UNITED STATES OF AMERICA
NUCLEAR REGULATORY COMMISSION

TEXAS UTILITIES GENERATING
COMPANY, et al.

Docket Nos. 50-445-1 and
50-446-1

CASE'S ANSWER TO APPLICANTS' STATEMENT OF MATERIAL FACTS
AS TO WHICH THERE IS NO GENUINE ISSUE REGARDING
CERTAIN CASE ALLEGATIONS REGARDING AWS AND ASME
CODE PROVISIONS RELATED TO DESIGN ISSUES

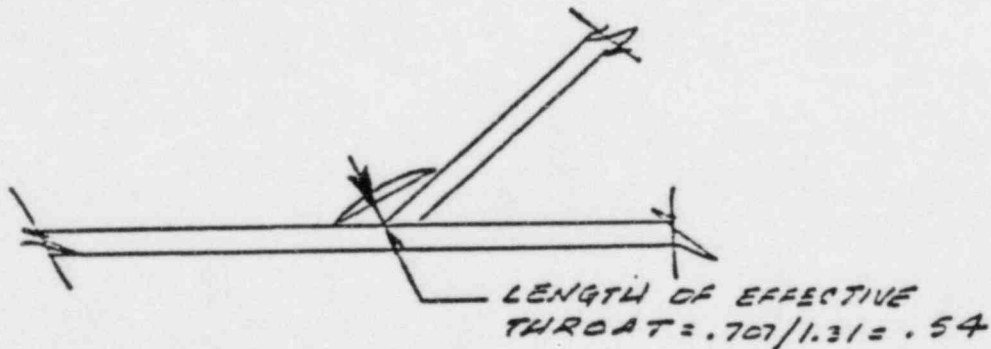
It is because of this .3 times yield strength provision that the ASME allowable appears to be more conservative. The reason it appears the ASME provision is more conservative is because it is based on yield strength; i.e., .3 times 42 ksi = 12.6 ksi, with no consideration for the effective throat. When the Applicants used the AWS procedure, it was based on tensile strength; that is, .3 times 70 ksi times .707 for the effective throat times a reduction for the skewed T-joint = 14.8 ksi, which would indicate that the capacity using the ASME procedure provides for a weaker or more conservative weld capacity. It should be noted that the example used by the Applicants did not consider the effective throat when using the ASME procedure, but was actually only evaluating the weld at the interface between the base metal and the

weld (shown as line A in the diagram below). In the example for the AWS procedure, the Applicants are looking at the capacity of the weld (shown as line B in the diagram below).

For a member that is skewed and welded on only one side of the skewed joint, as shown in the diagram below, the capacity of the joint using the AWS procedure for the angle shown is equal to .3 times 70 ksi times .707 for the effective throat times 1.31 the coefficient set forth in Appendix B, Table B, of the AWS Code = 11.3 kips/inch.

This value is less than the ASME allowable value of 12.6 kips/inch. So in this regard, the AWS code is more conservative than the ASME code.

FIGURE 3

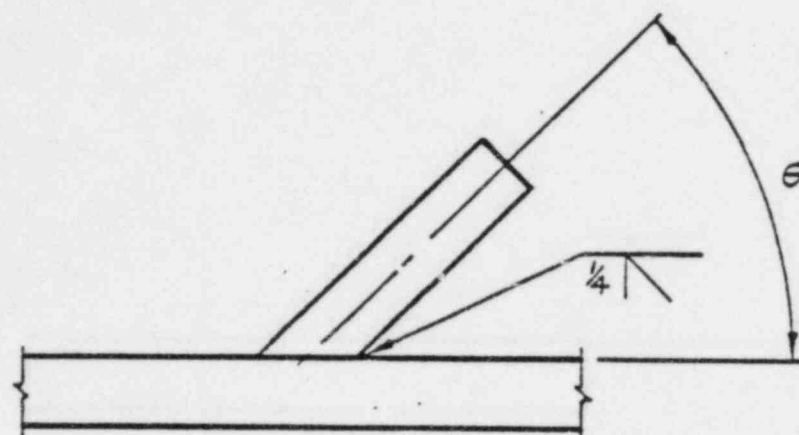
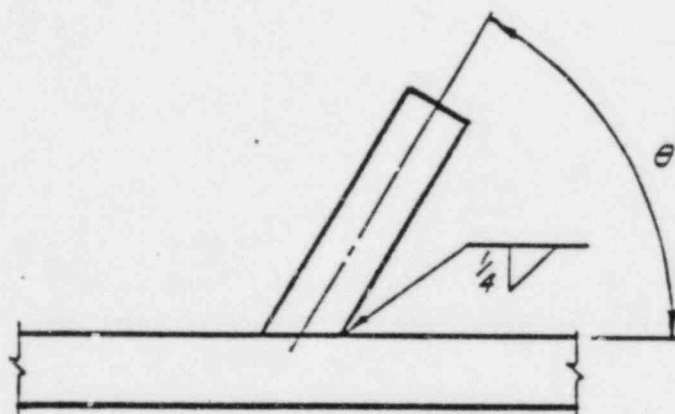
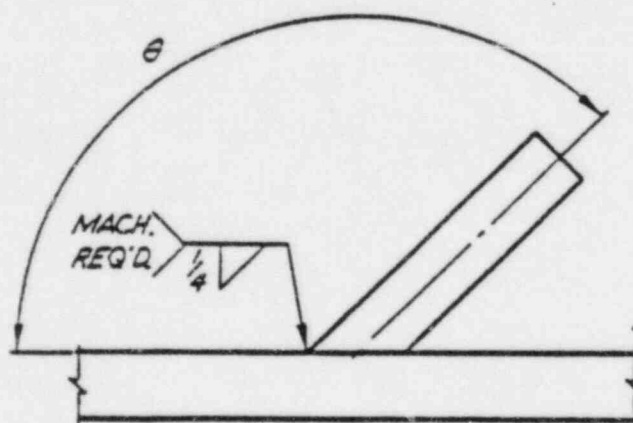
I disagree with this statement. In the first place, the type of information which should be considered to be "documentation" is such as that contained in the PSE Manual. As shown by the attached pages from the PSE Manual (cover page, pages 1 and 2, and Figure 3, of Section XI, Weld Calculations, from CASE Exhibit 716, which was provided to the Board and parties but never officially accepted into evidence), in the procedures being used as of 5/11/82, Applicants did not include information as to how to calculate the effective throat. This appears to be in violation of 10 CFR Part 50, Appendix A, Criterion 1, in that Applicants should have incorporated Appendix B, Table B, of AWS D1.1 into their procedures to calculate the effective

throat of a skewed fillet weld, since ASME does not contain such a table and is therefore not sufficient.

As indicated in the CPPA-22,616 memorandum, the welds in question are those welds which are greater than 90 degrees but still less than 135 degrees. In diagram B of Attachment 1 to CPPA-22,616, the diagram indicates that the size of weld (not the effective throat that engineering was using) was a value S, but does not state how the effective throat is calculated. If engineering is using the value S as the effective throat, they are grossly in error. As shown in Table B of Appendix B of the AWS Code, when a 1" weld is sized when the members are perpendicular to one another, the size of fillet weld required to provide the same capacity increases to 1.31" when the members are at 135 degrees to one another.

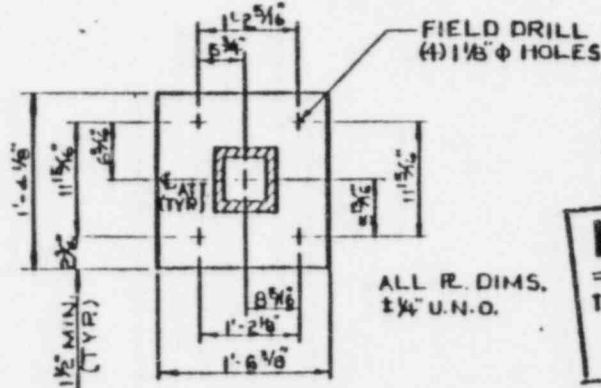
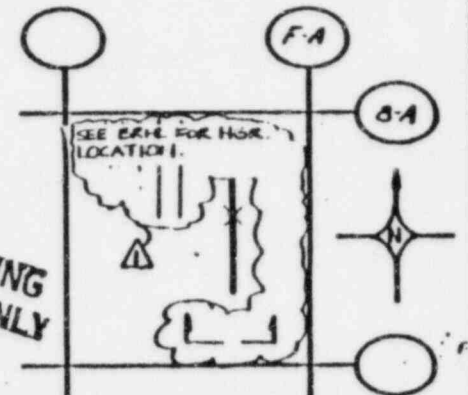
It should also be pointed out that when the AWS Code addresses a Beta equal to one, it is referring only to those connections where the branch member and the main member have the same width, and this is the only condition the Applicants are addressing in their Motion for Summary Disposition. For example, referring to attached drawing CC-2-011-711-A53R, the connection for members 7 and 8 will have a Beta equal to 1, since they are both 4" tube steel members.

It should be noted that the connection for members 8 and 9 have a Beta of .75, and this is known as a stepped connection. The connection for members 8 and 9 is not addressed in ASME XVII-2261.2 in any way, shape, or form, but this is a common connection at CPSES, and it is addressed in AWS D1.1, at 10.5.1. In addition, the connection between item 5 and tube steel member item 6, shown in drawing CT-1-013-015-S32K, is not considered in the ASME code on how to handle the punching shear stresses for that connection. The portion of this issue which Applicants have addressed in their Motion for Summary Disposition should not be construed to address all of our concerns in this regard.
